**Subject: Tahoe Basin Area Plan and Tahoe City Lodge Draft Environmental Impact Report/Study**

Thank you for the opportunity to comment on the draft Environmental Impact Report/Study (DEIR/S) for the Tahoe Basin Area Plan (TBAP) and Tahoe City Lodge (TCL). We appreciate the time taken by staff to present this information at numerous public hearings and respond to our requests for DEIR/S documents in a timely manner. However, we are concerned with the failure of the DEIR/S to adequately analyze numerous impacts as well as include sufficient mitigation measures. We also reiterate our concerns as stated in our Notice of Preparation (NOP) comments that the TBAP and TCL should be analyzed separately. Key concerns include:

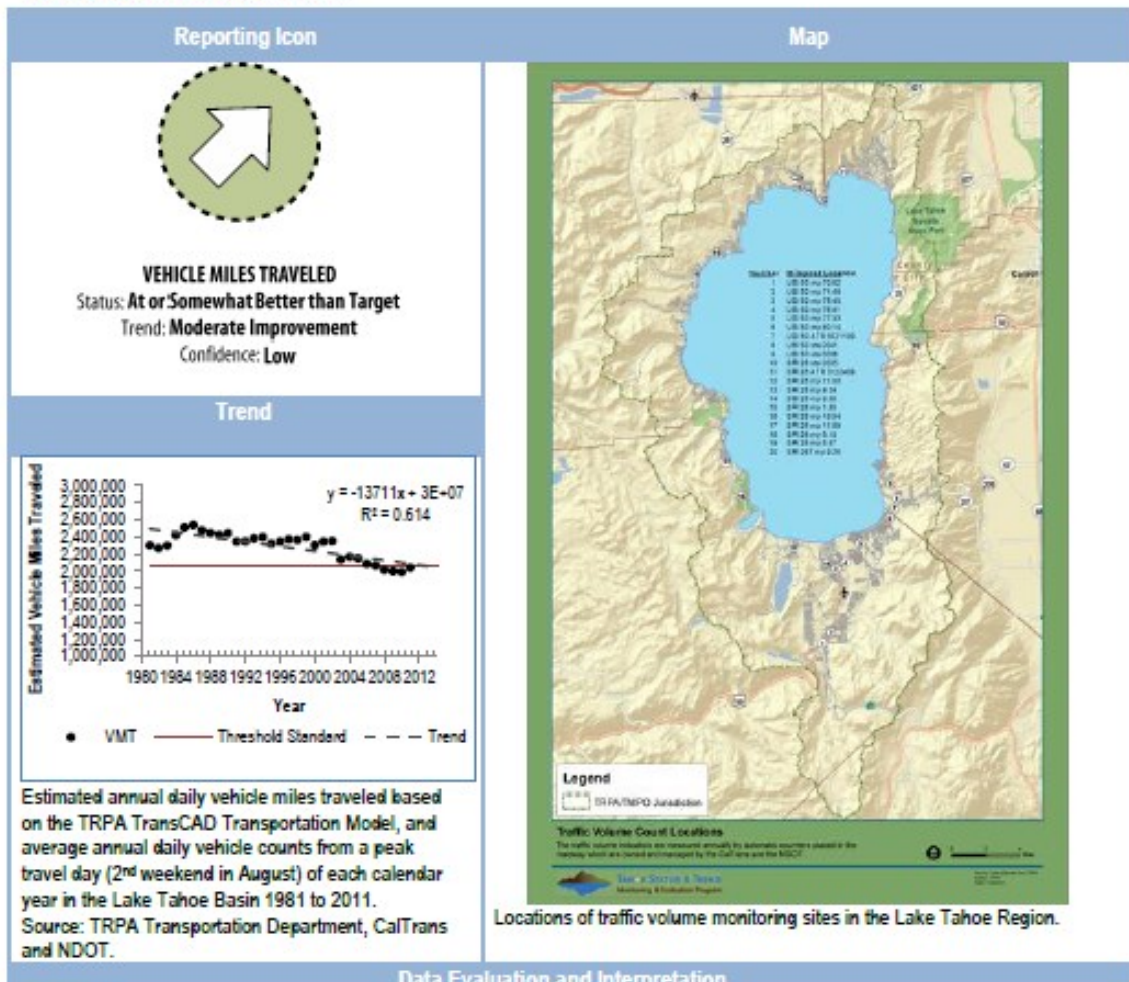
The FEIR/S must assess the potential worst-case VMT impacts in the TBAP area associated with the VMT that may result from existing infrastructure. This may be reflected by assessment of the maximum traffic levels that have occurred in the area since the current infrastructure was built, as can be gleaned from the long term VMT counts presented in the RPU EIS (cited previously):

Above image taken from Map 3 of the final 2012 RPU (legend on left)

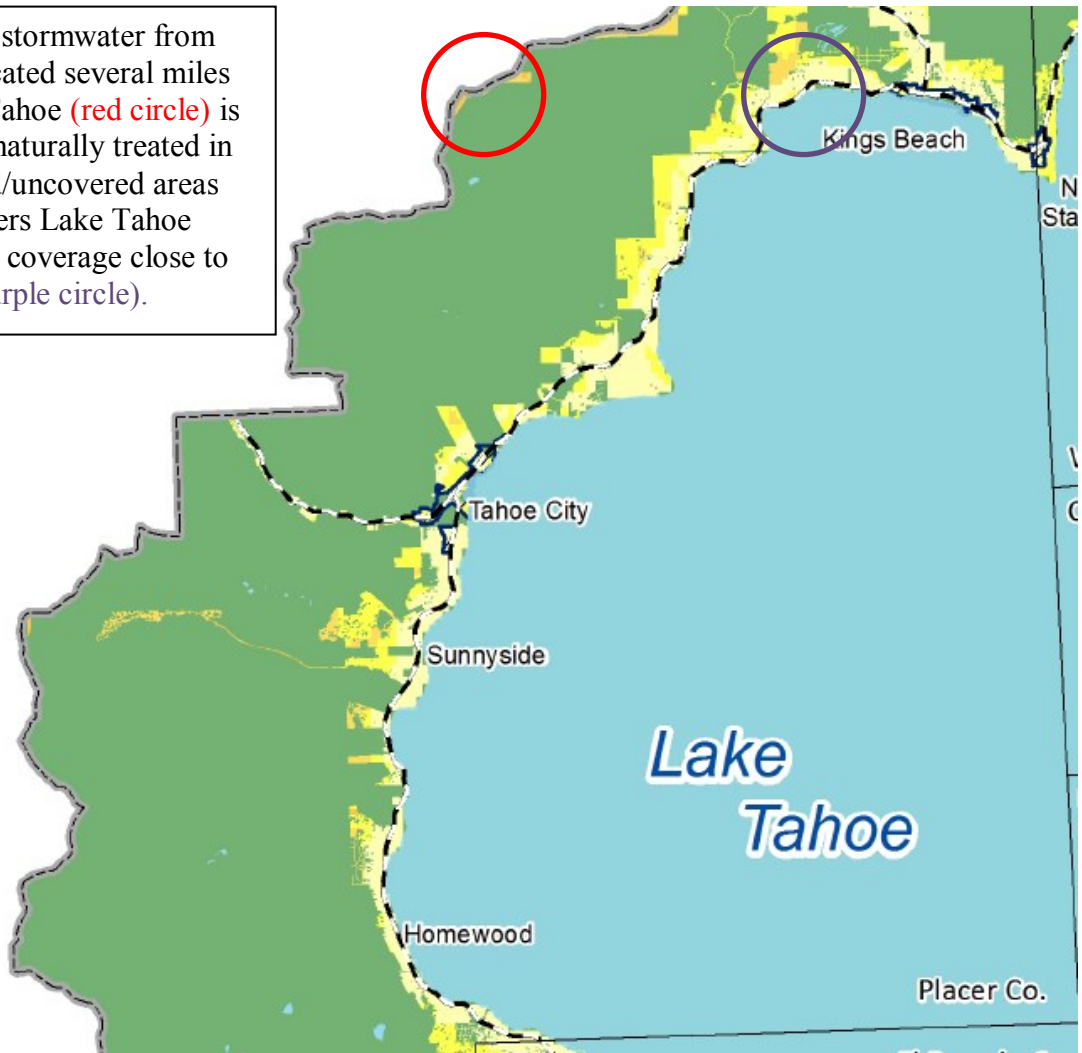
The annotated figure below provides an example of how the transfer program may transfer development/coverage from areas where it is causing no or minor impacts to Lake Tahoe as a result of adequate natural infiltration to areas where associated runoff is contributing more pollution to Lake Tahoe due to the absence of areas for natural infiltration.
